## Product Change Notification - SYST-13VHLJ680

ERRATA - dsPIC33FJ32GS406/606/608/610 and dsPIC33FJ64GS406/606/608/610 Silicon Errata and Document Clarification Document Revision

## dsPIC33FJ32GS406/606/608/610 and dsPIC33FJ64GS406/606/608/610 Family Silicon Errata and Data Sheet Clarification

FIGURE 1: TIMING DIAGRAMS FOR CENTER-ALIGNED AND EDGE-ALIGNED MODES

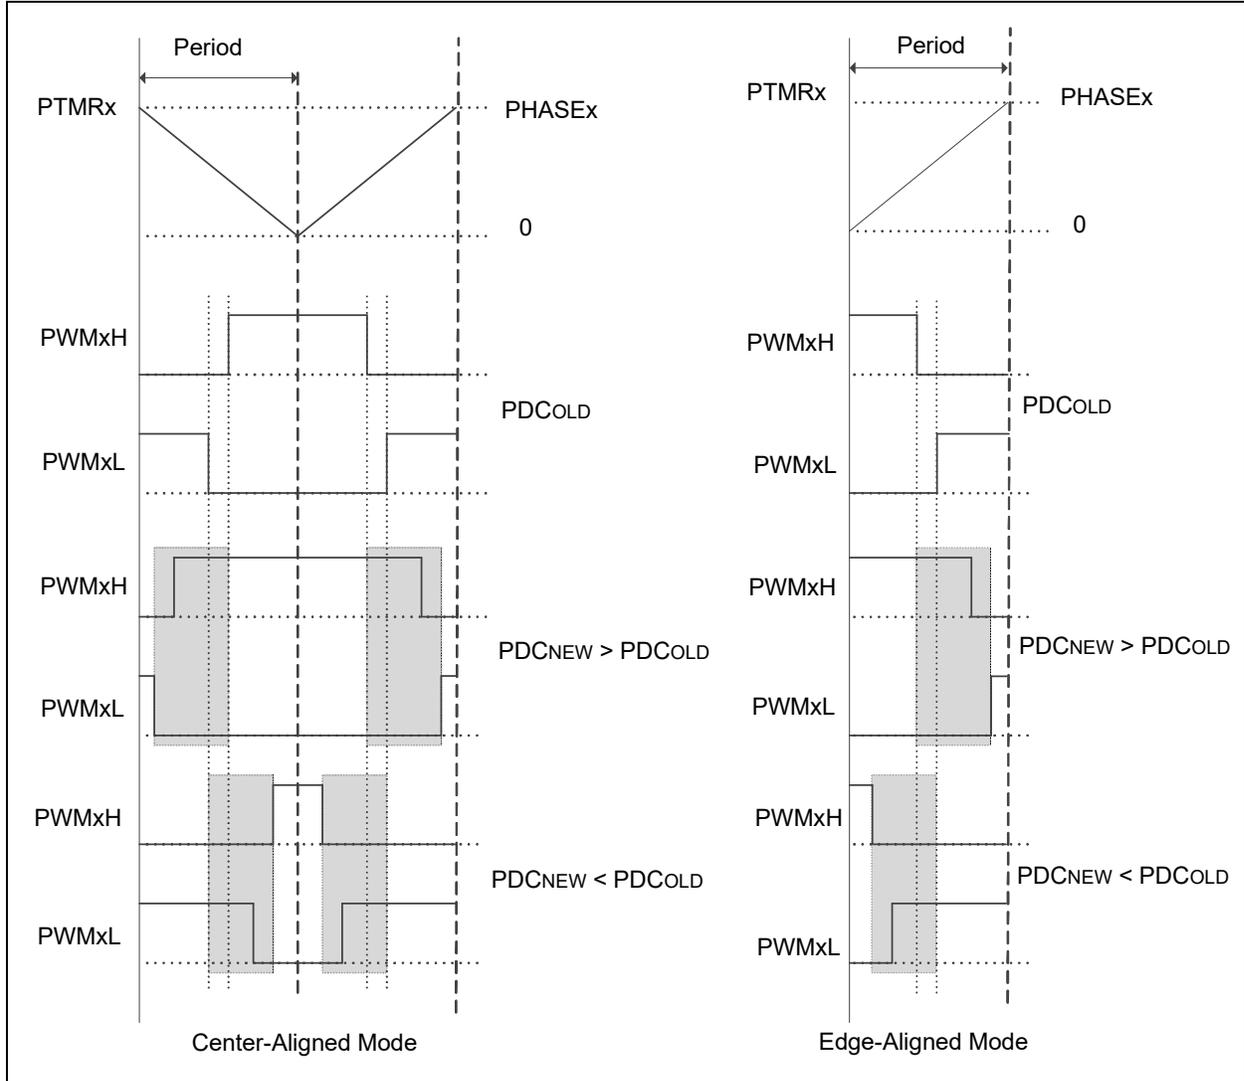
The PWMx generator may not assert dead time on the edges of transitions. This has been observed when all of the following conditions are present:

- The PWMx generator is configured to operate in Complementary mode with the independent time base or master time base;
- Immediate update is enabled; and
- The value in the PDCx register is updated in such a manner that the PWMxH and PWMxL outputs make an immediate transition.

The current duty cycle, PDCOLD, newly calculated duty cycle, PDCNEW, and the point at which the write to the Duty Cycle register occurs within the PWMx time base, will determine if the PWMxH and PWMxL outputs make an immediate transition. PWMxH and PWMxL outputs make an immediate transition if the Duty Cycle register is written with a new value, PDCNEW, at a point of time when the PWMx time base is counting a value that is in between PDCNEW and PDCOLD. Additionally, writing to the Duty Cycle register close to the instant of time where dead time is being applied may result in reduced dead time, effective on the PWMxH and PWMxL transition edges.

In [Figure 1](#) (following page), if the duty cycle write occurred in the shaded box, then PWMxH and PWMxL will make an immediate transition without dead time.

None. However, in most applications the duty cycle update timing can be controlled using the TRIGx trigger or Special Event Trigger, such that the above mentioned conditions are avoided altogether.

**FIGURE 2: ISSUE EXAMPLE FOR REDUNDANT OUTPUT MODE**

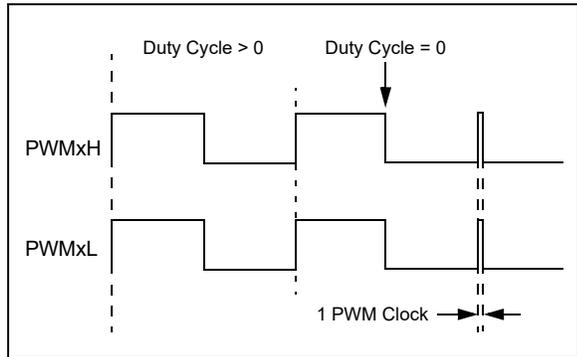
In Redundant Output mode (IOCONx[11:10] = 01) and Push-Pull Output mode (IOCONx[11:10] = 10), with the Immediate Update Enable bit disabled (PWMCONx[0] = 0), when the Duty Cycle register is updated from a non-zero value to zero, a glitch pulse of a width equal to one PWM clock will appear at the next PWM period boundary, as shown in Figure 2 (for the Redundant Output mode). The Duty Cycle register refers to the PDCx register if PWMCONx[8] = 0 or the MDC register if PWMCONx[8] = 1.

If the application requires a zero duty cycle output, there are two possible work around methods:

1. Use the PWM override feature to override the PWM output to a low state instead of writing to the Duty Cycle register. In order to switch back to a non-zero duty cycle output, turn off the PWM override. The override-on and override-off events must be timed close to the PWM period boundary if the IOCONx register has been configured with IOCONx[0] = 0 (i.e., output overrides through the OVDDAT[1:0] bits occur on the next CPU clock boundary).
2. Enable the Immediate Update Enable bit (PWMCONx[0] = 1) while configuring the PWMx module (i.e., before enabling the PWMx module, PTCON[15] = 1). With the Immediate Update enabled, writes to the Duty Cycle register can have an immediate effect on the PWM output. Therefore, the duty cycle write operations must be timed close to the PWM period boundary in order to avoid distortions in the PWM output.

**FIGURE 3:**

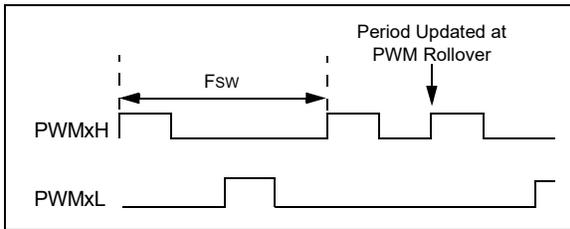
When the PWM module is configured for Push-Pull mode (IOCONx[11:10] = 10) with the Enable Immediate Period Update bit enabled (PTCON [10] = 1), a write to the Period register that coincides with the period rollover event may cause the push-pull output logic to produce back-to-back pulses on the PWMx pins (Figure 3).

Ensure that the update to the PWM Period register occurs away from the PWM rollover event by setting the EIPU bit (PTCON[10] = 1). Use either the PWM Special Event Trigger (SEVTCMP) or the PWM Primary Trigger (TRIGx) to generate a PWM Interrupt Service Routine (ISR) near the start of the PWM cycle. This ISR will ensure that period writes do not occur near the PWM period rollover event.

**FIGURE 4: ENCODER IN THE SECTOR AROUND THE INDEX MARK**

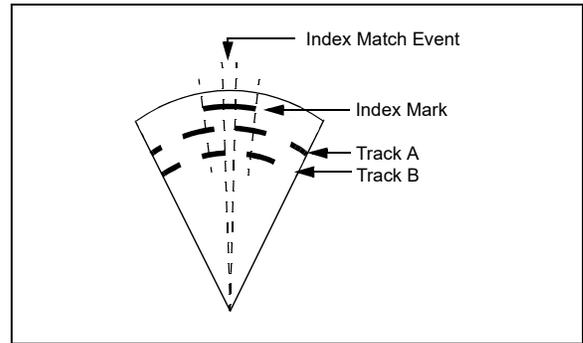
When the QEI module is used in 4x mode with Index Pulse Reset (QEIM[2:0] = 110), the value of the POSxCNT register may not transition (rollover or underflow) from zero to the maximum count value as expected.

This issue is most likely to be seen in specific motor applications using a rotation encoder with an ungated index pulse, operating at near zero speed and/or in the presence of mechanical vibration. In these applications, the encoder may change direction and incrementally rock back and forth. If this happens with the encoder positioned in the vicinity of its index mark, the module will detect the first index match event as the encoder rotates into the index match event area, but not subsequent events if it drifts into and out of that position but stays within the index mark area (Figure 4). If the encoder count increments or decrements in only one direction, the index match will only occur once.

As a result of this, the value of POSxCNT may leave its expected range of 0 to maximum count (defined as the number of encoder pulses per revolution, minus 1), resulting in erroneous reporting of the rotor's position.

None.

**FIGURE 5: ENCODER IN THE SECTOR AROUND THE INDEX MARK (ONE COUNT WIDTH INDEX)**

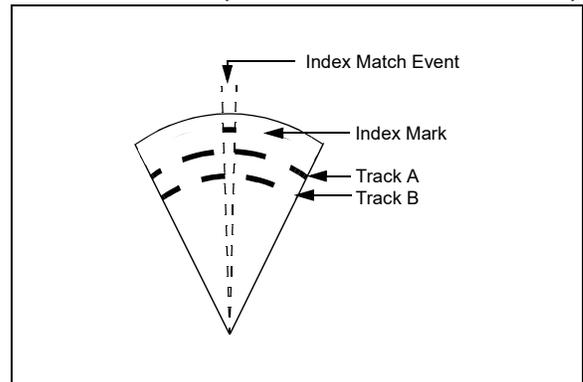
This issue is not seen when the encoder uses an index mark that is one encoder count in width (Figure 5).
